SERVICE No-324 BULLETIN

Piper Aircraft Corporation

September 29, 1970 S/M

Vacuum Pump Adapter Drive Assembly

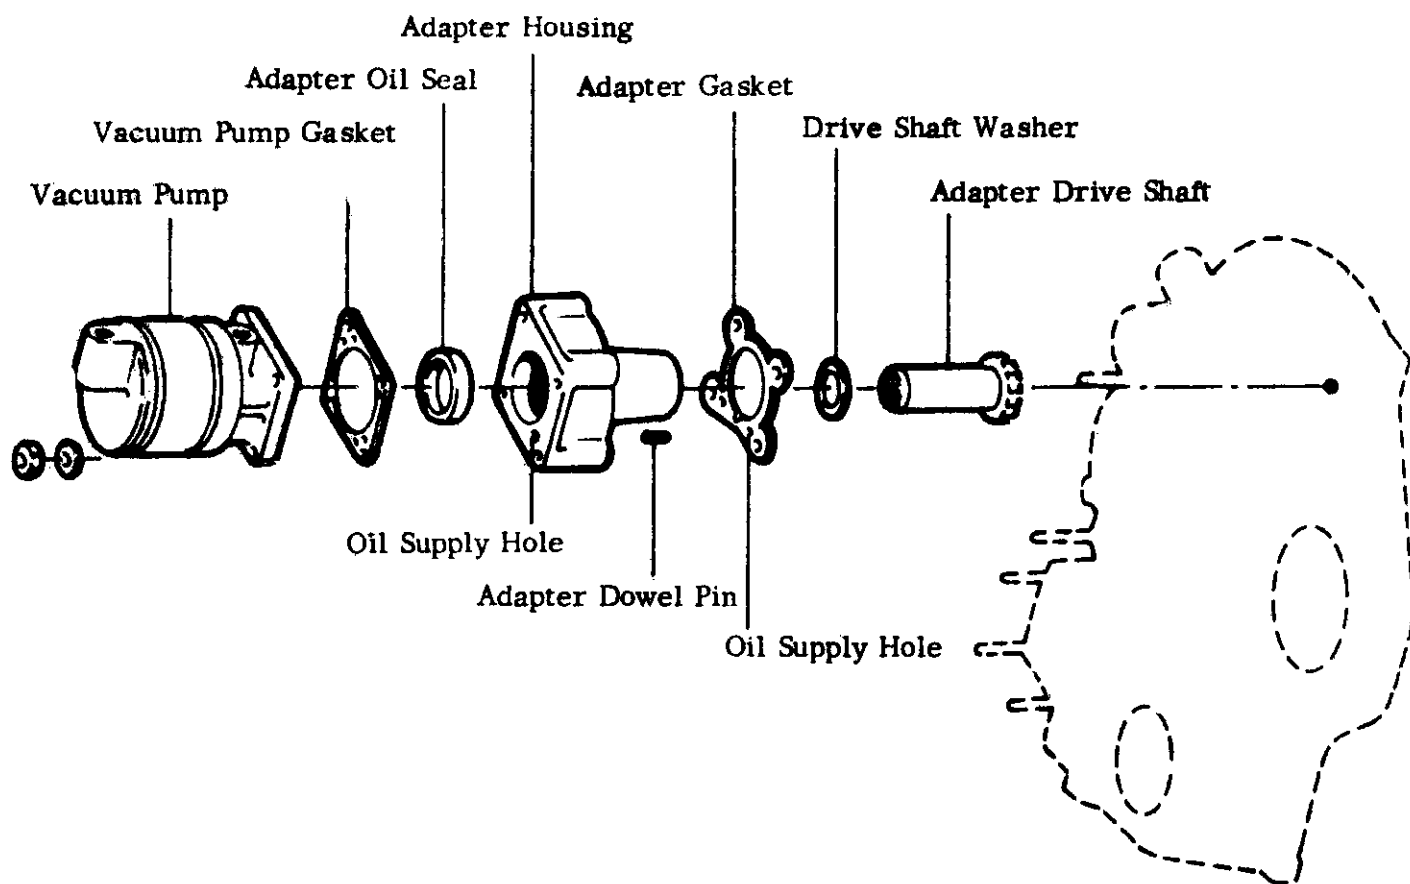
To provide instructions for an inspection of the vacuum pump adapter drive assembly (reference attached sketch for an illustration of the area to be inspected).

- I. Remove vacuum pump and vacuum pump adapter assembly from engine.
- II. Remove drive shaft from adapter housing and inspect the shaft for any sign of aluminum pick up on shaft at either end of shaft where it contacts adapter bearing bore.
- III. Inspect the adapter housing for the following:
 - a. Any evidence of inadequate lubrication resulting from foreign chips in oil supply hole.
 - b. Omission of oil supply hole.
 - c. Improper location of dowel.
 - d. Improper indexing of drive adapter assembly to accessory pad.
- IV. Inspect gasket, Lycoming part number 61183, for omission of oil transfer hole.

IF ANY DISCREPANCIES ARE FOUND, DO NOT ATTEMPT TO REPAIR. Contact your local Lycoming Regional Representative or Lycoming Service Department for further instructions.

- V. If the above referenced inspection procedure discloses no discrepancies, clean and lubricate (with SAE 50 oil) all parts that were inspected and reinstall on engine torque all nuts to 50 to 70 inch pounds.
